UNITED STATES PATENT AND TRADEMARK OFFICE

APPLICATION NO.	FILING DATE	FIRST NAMED INVENTOR	ATTORNEY DOCKET NO.	CONFIRMATION NO.
09/960,341	09/24/2001	Akihiro Komatsu	Q66198	4615

Office Action Summary

DETAILED ACTION

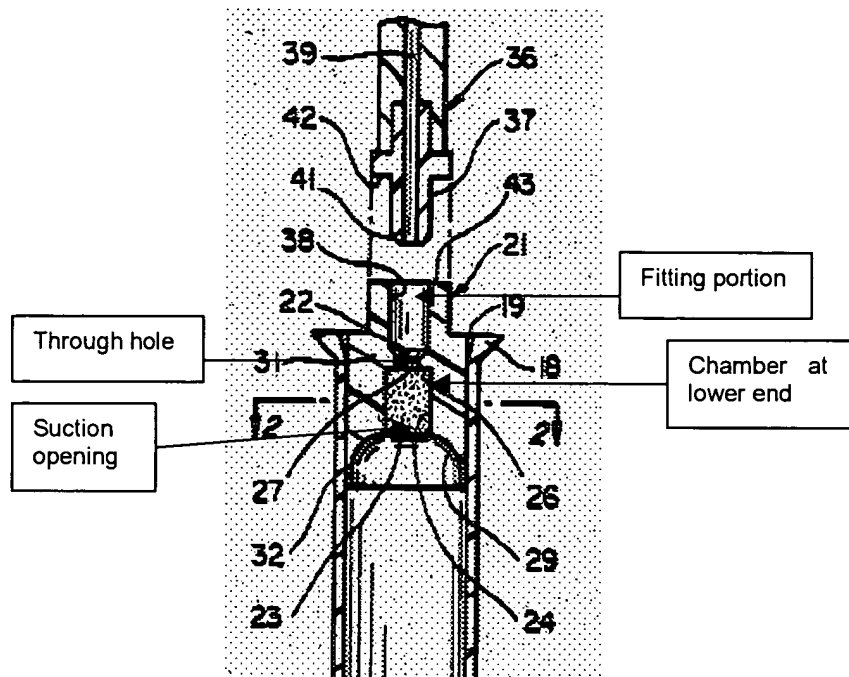
8. Claims 1-4 and 6-8 are rejected under 35 U.S.C. 102(b) as being anticipated by Mar US 4,644,807.

Mar discloses a device that is structurally equivalent to that as claimed by applicant (see figure below).

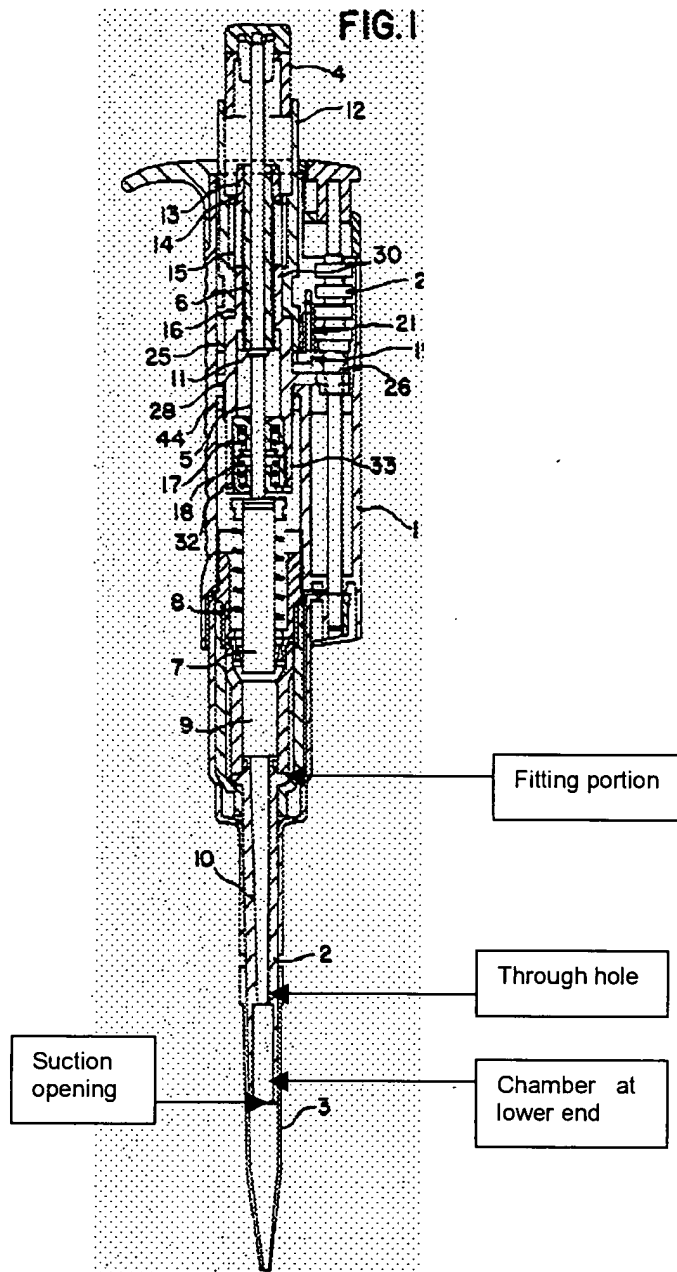
9. Claims 1-4, 6, and 8 are rejected under 35 U.S.C. 102(b) as being anticipated by Sabloewski, US 5,531,131.

Sabloewski discloses a device structurally equivalent to that as claimed by applicant as indicated by the figure below.

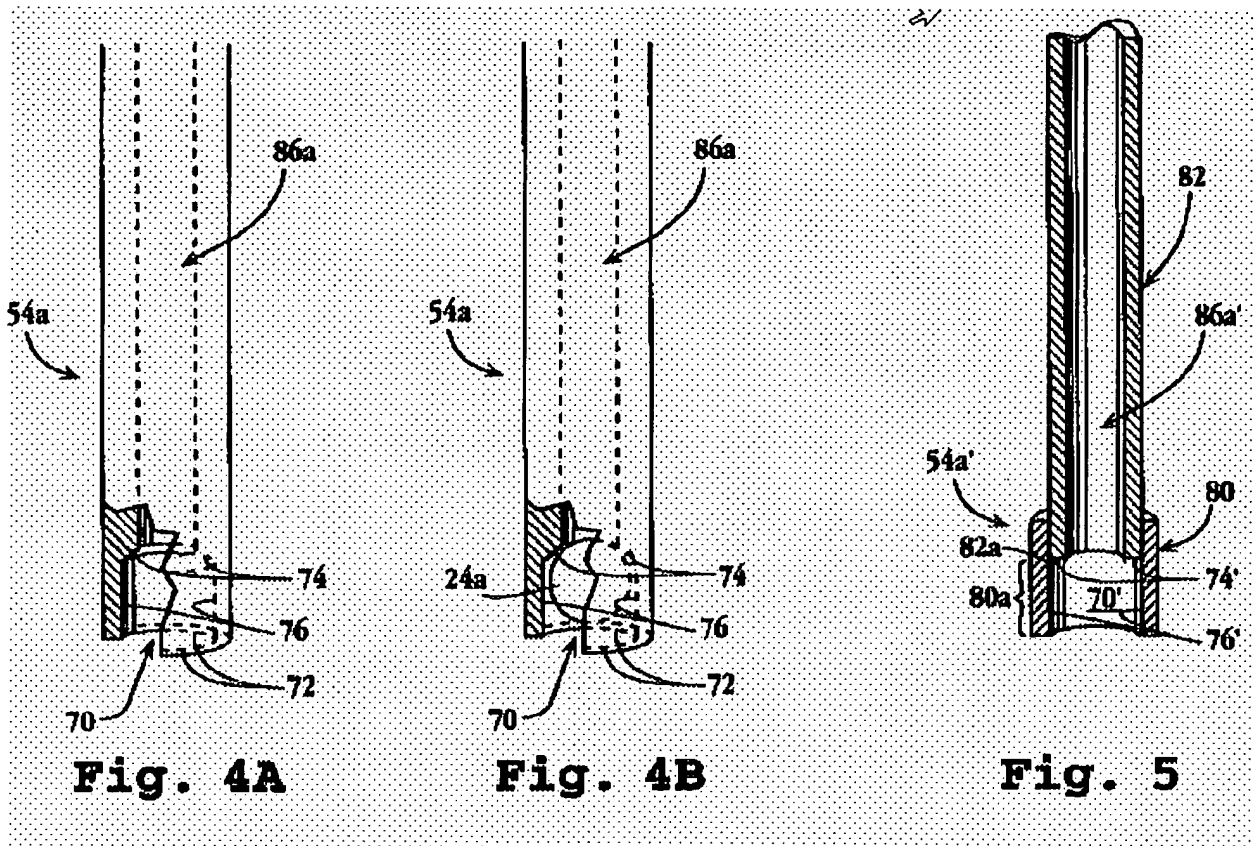
11. Claims 1, 5-6, 8 rejected under 35 U.S.C. 102(e) as being anticipated by Vann et al. US 20003/0021734.

Van et al. discloses a delivery system. The system may comprise a substantially T-shaped frame, denoted generally as 60, supports both extractors 50a, 50b. More particularly, frame 60 includes an upper, horizontal Where a tube already having a longitudinally extending bore or lumen, such as at 86a in FIG. 4(A), is used, cavity 70 can be formed by drilling a counterbore into an end of the tube, with the counterbore having a diameter greater than the inner diameter of the lumen 86a, yet smaller than the outer diameter of the tube.

As seen in the figures above the projections (tips) have a lower cavity (chamber) of constant cross-sectional area terminating at an upper end with a through hole of a smaller cross-sectional area and the lower end has a hole that is equal to the cross-sectional area of the that of the cavity (see also figure 8).
